Tube R2C69, SG24, High Frequency Probe

Figure 1 Profile of the defect in tube R2 C69 of steam generator 24 as measured with the high-frequency plus-point at 1000 kHz and 800 kHz.

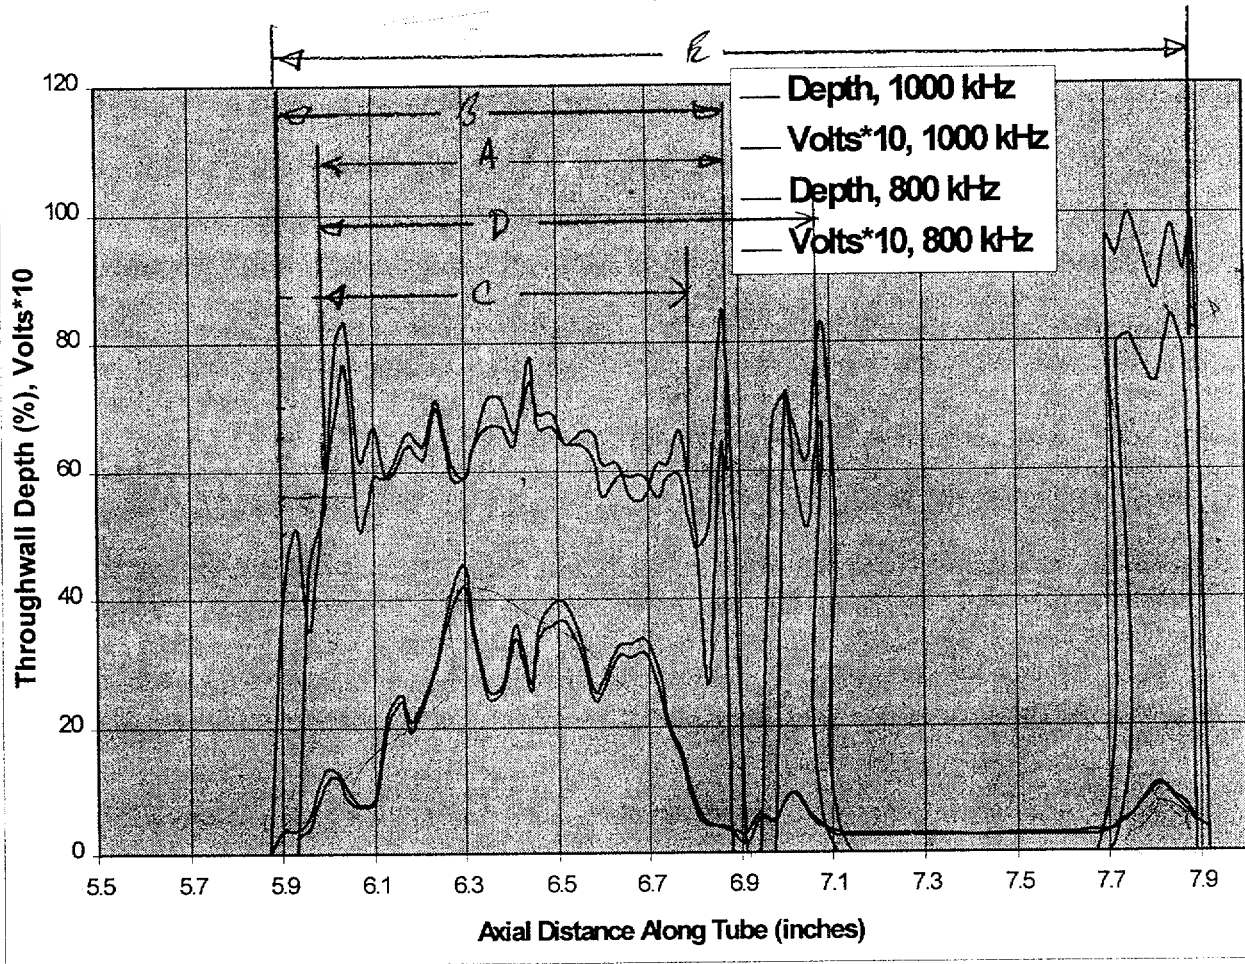
$d_A = 62\%$, $L_A = -1$, $P_A = 5978$ $d_D = 53\%$, $L_D = 1.1$, $P_D = 6943$
 $d_B = 58\%$, $L_B = 1.0$, $P_B = 6384$
 $d_E = 60\%$, $L_E = 1.0$, $P_E = 6139$ $d_E = 40\%$, $L_E = 2.0$, $P_E = 8372$

However, this tube had very little noise even with the old mini

Tube R2C74, SG24, High Frequency Probe

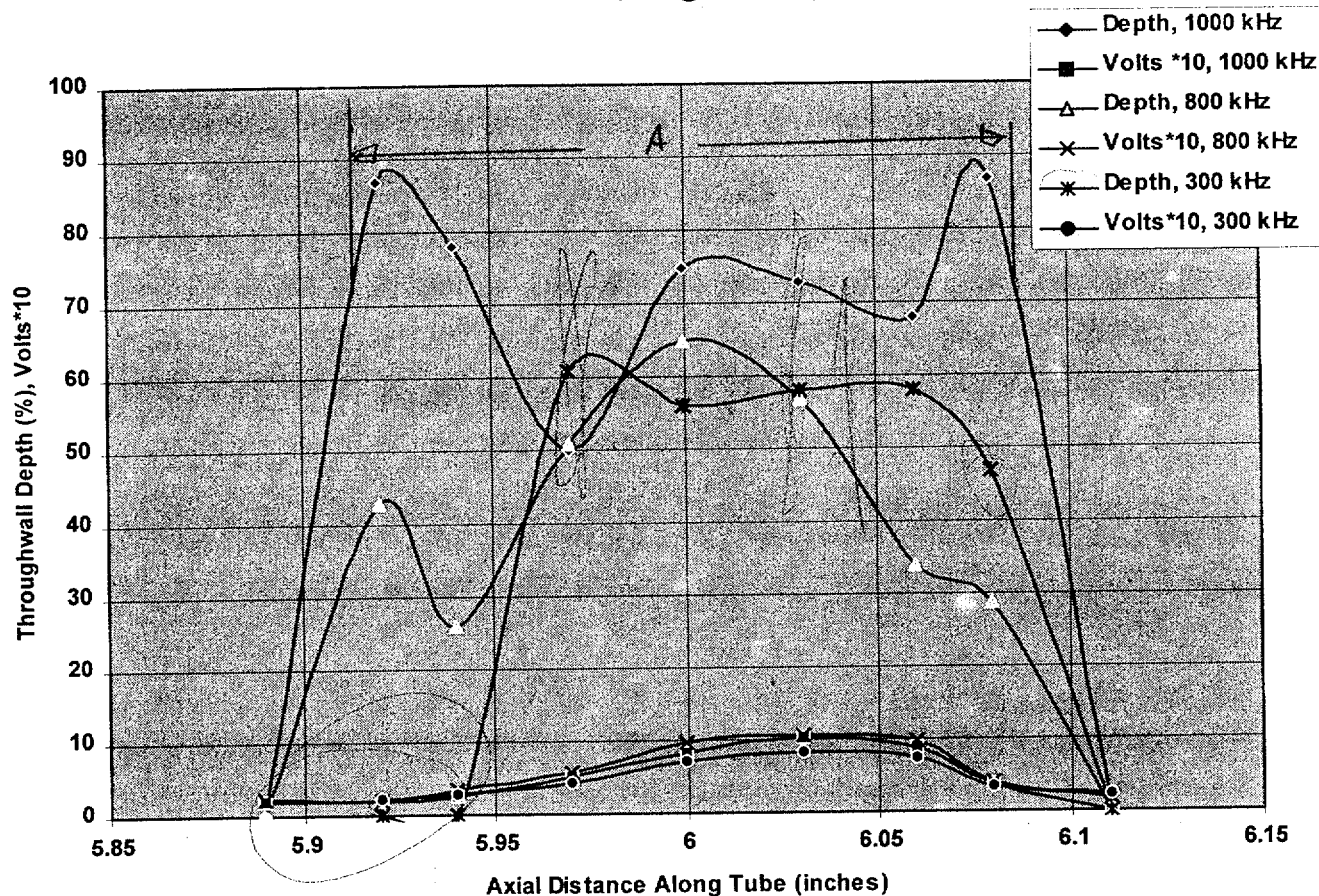
$$L_{TOT} = .42 - .45$$

$$L_A = .38, d_A = 52\%, P_A = 7597$$

$$L_B = .24, d_B = 60\%, P_B = 8058$$

$$L_C = .16, d_C = 70\%, P_C = 9495$$

Tube R2C71, SG24, High Frequency Probe

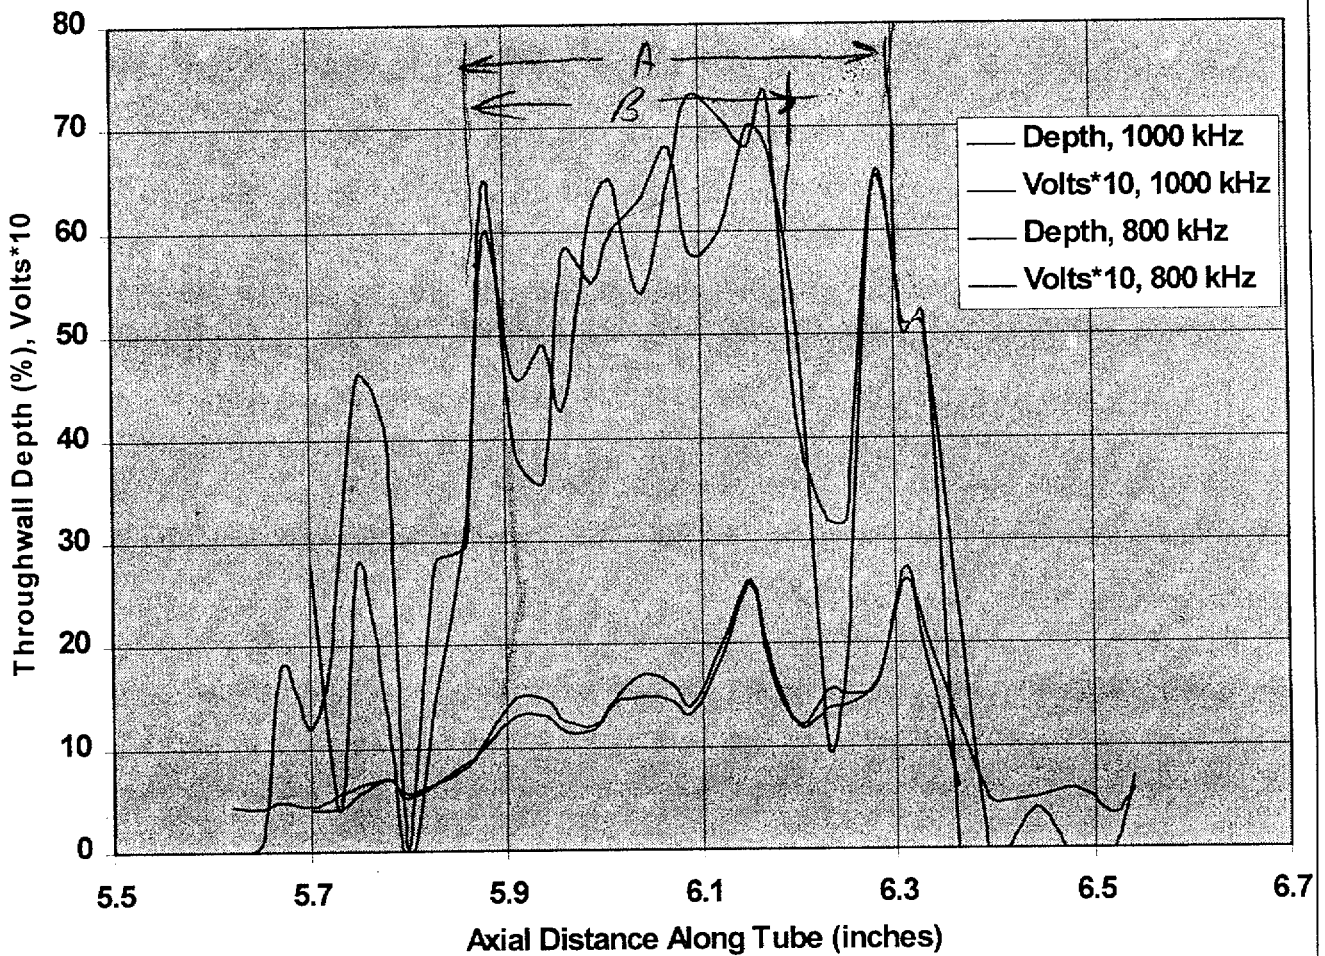
Missed with mid-range probe

What was the noise level

Used 9987N
over all length
to explain leakage
at 1741 psi
Need 95% TW for
leakage at 2500

$L_A = .43$, $d_A = 55\%$, $P_A = 7059$ psi, no leakage
at 4500 psi

$L_B = .3$, $d_B = 60\%$, $P_B = 7120$ psi, no leakage

$L_C = .25$, $d_C = 65$, $P_C = 7892$ psi, no leak

$L_d = .10$, $d_d = 70$, $P_d = 10567$, no leak
